OUTLINE OF CHANGES TO APPROVED SCHEME (REF:0221328)

There have been some minor changes to the approved scheme as a part of this non-material amendment application, however these have minimal impact on the overall design of the original scheme.

SITE LAYOUT PLAN

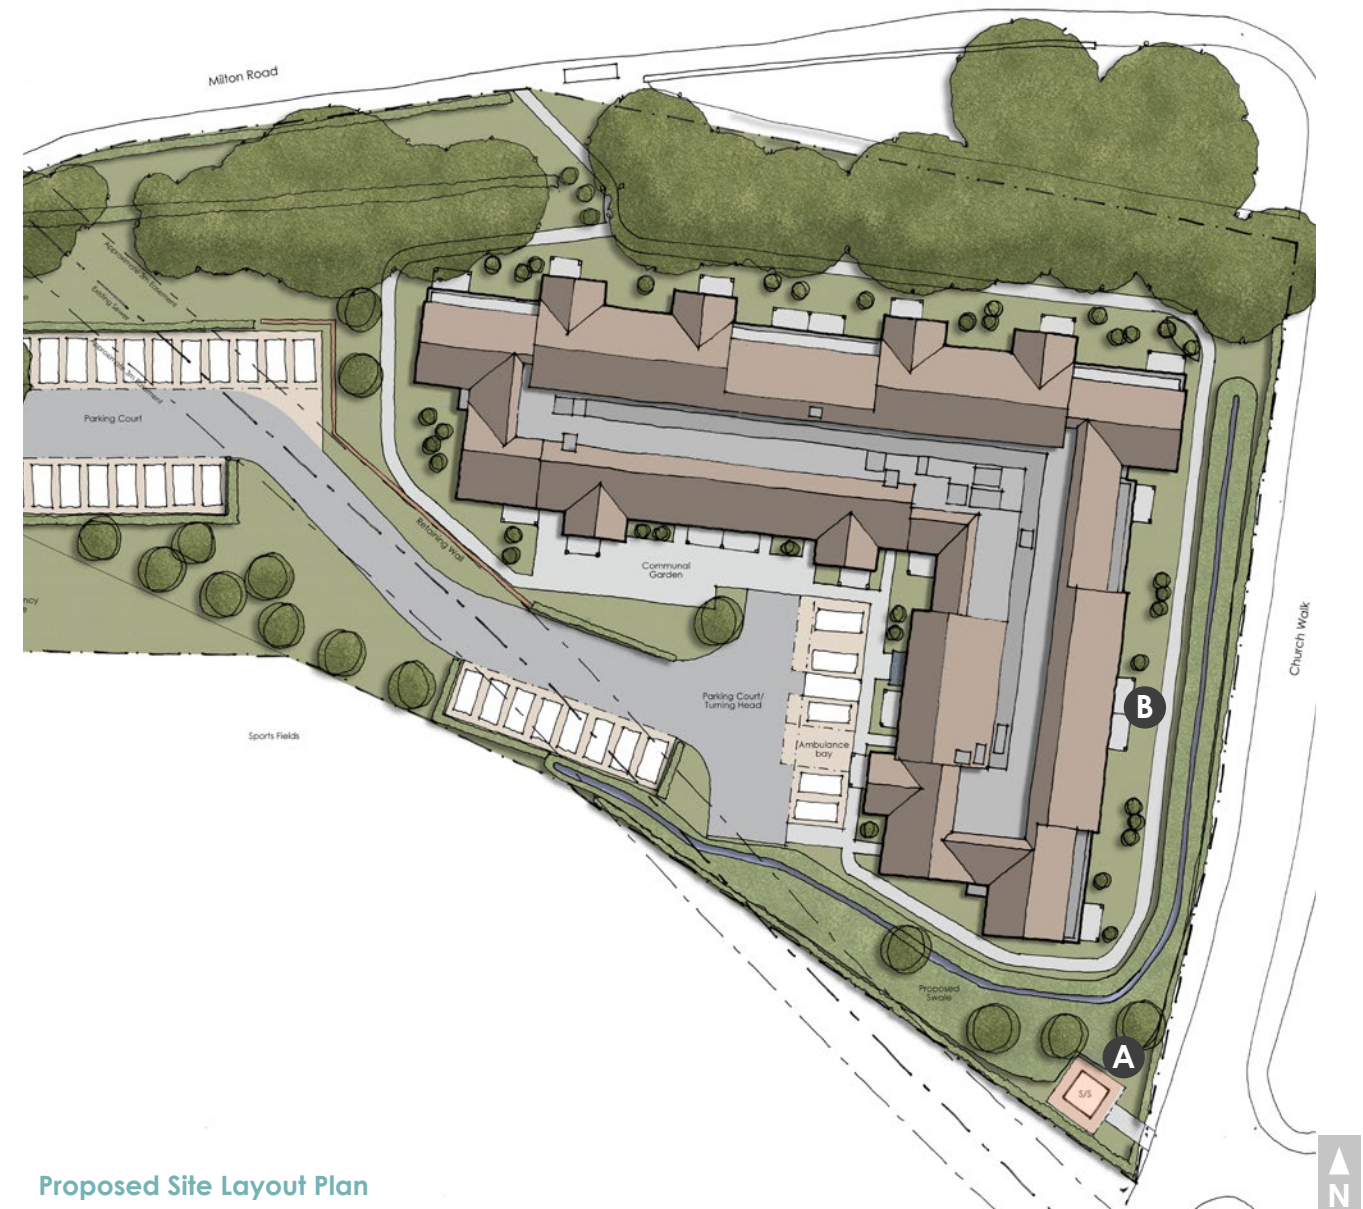
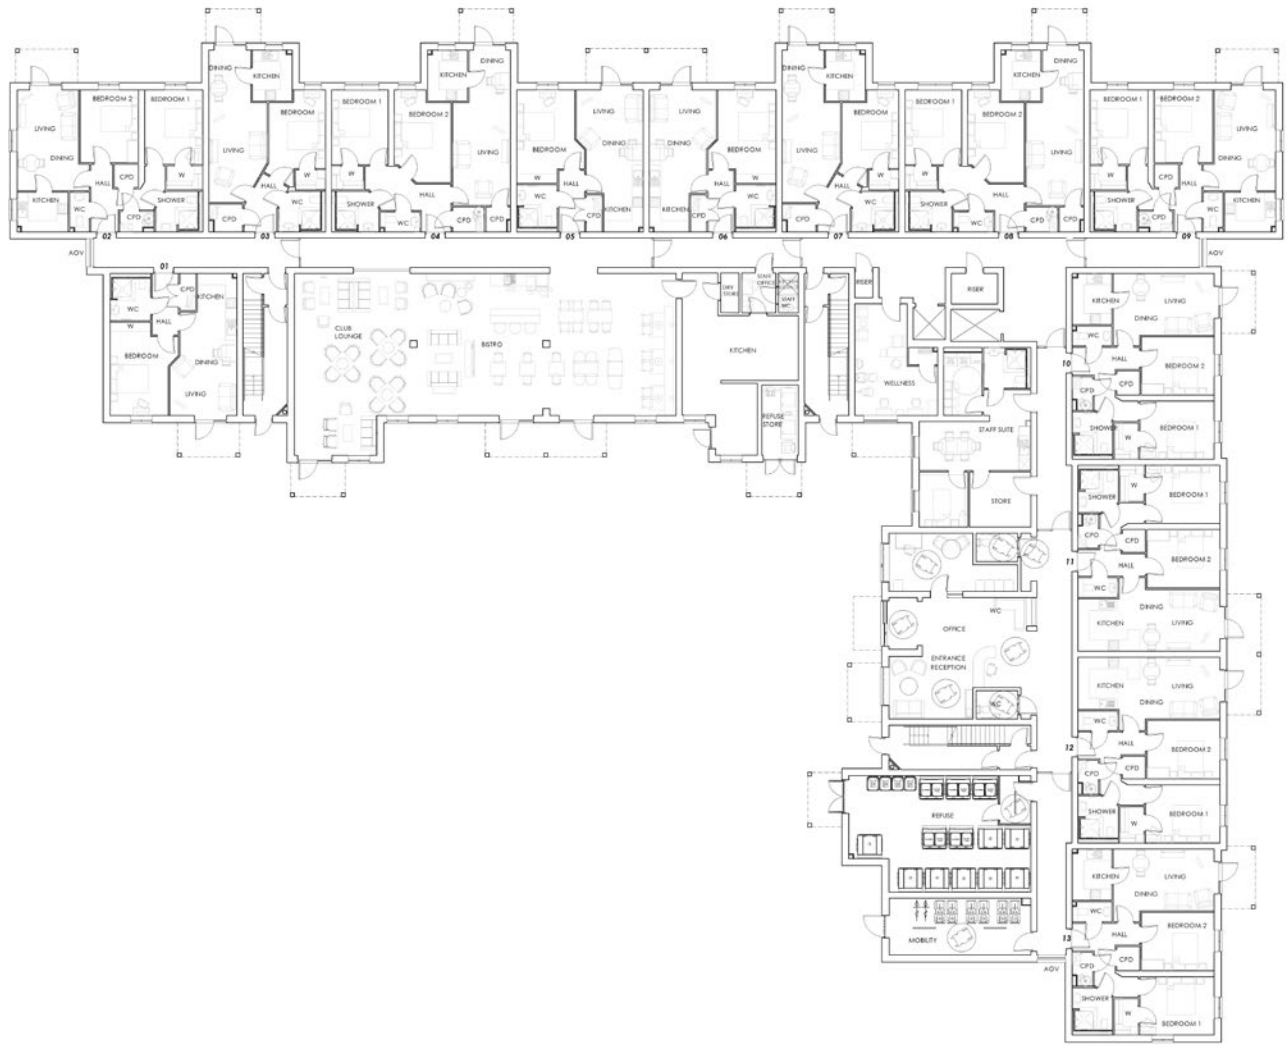
- A** Substation repositioned to southeastern corner of site, now accessed from Church Walk.
- B** Projecting units in central portion of eastern elevation to Church Walk aligned / projection removed, replaced with brick details.
- C** Balcony surrounds removed, replaced by simple balcony posts.
- D** Opaque balustrades to balconies replaced with glazed panels.
- E** Some window depths and location of transoms altered to improve proportions.

GROUND FLOOR PLAN

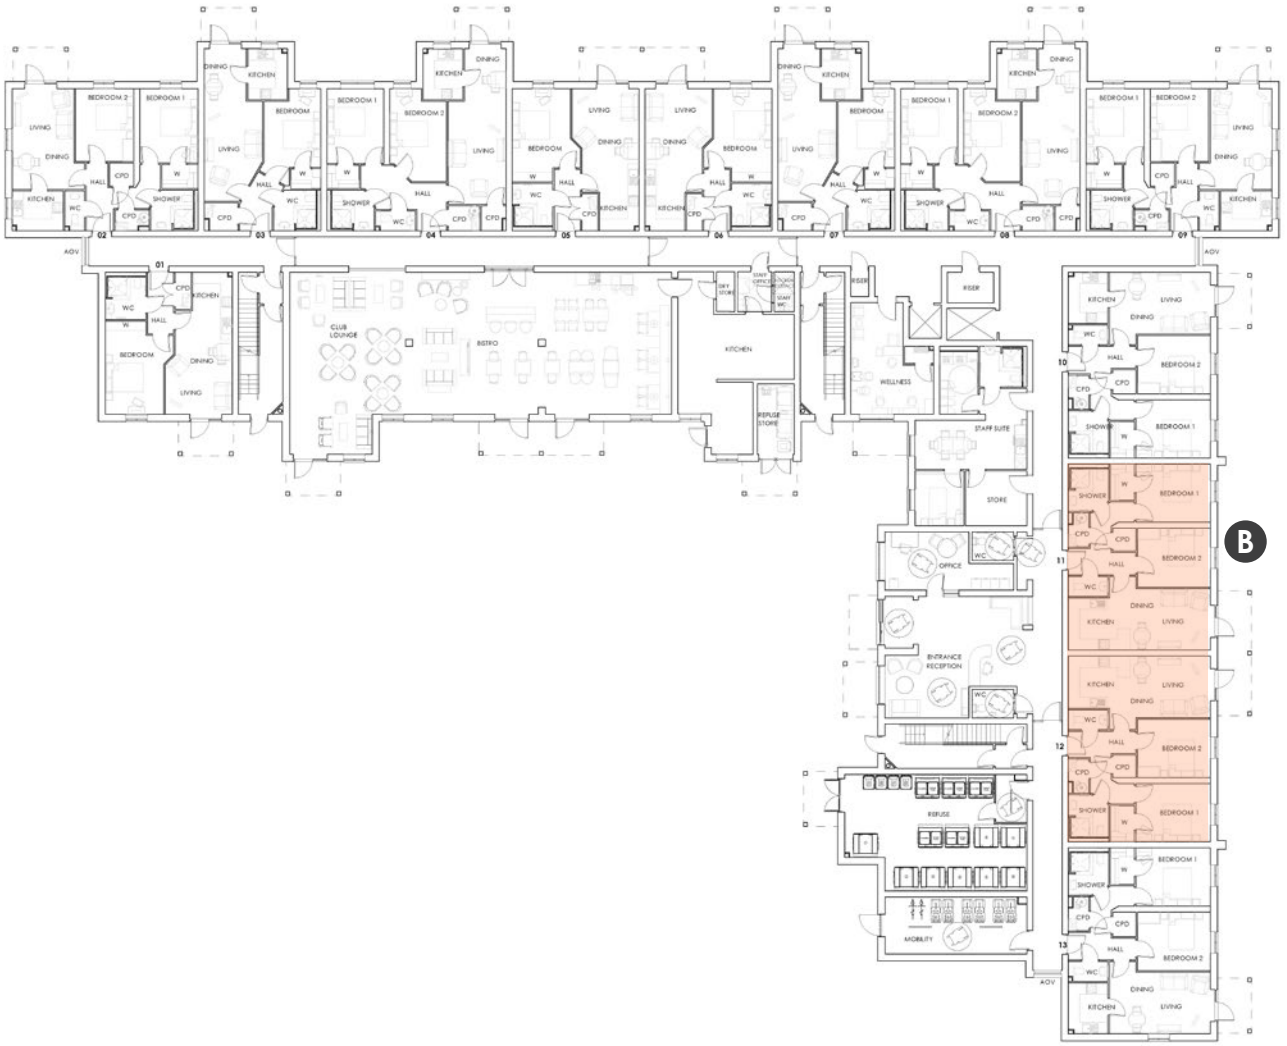
- A** Substation repositioned to southeastern corner of site, now accessed from Church Walk.
- B** Projecting units in central portion of eastern elevation to Church Walk aligned / projection removed, replaced with brick details.

- C** Balcony surrounds removed, replaced by simple balcony posts.
- D** Opaque balustrades to balconies replaced with glazed panels.

- E** Some window depths and location of transoms altered to improve proportions.
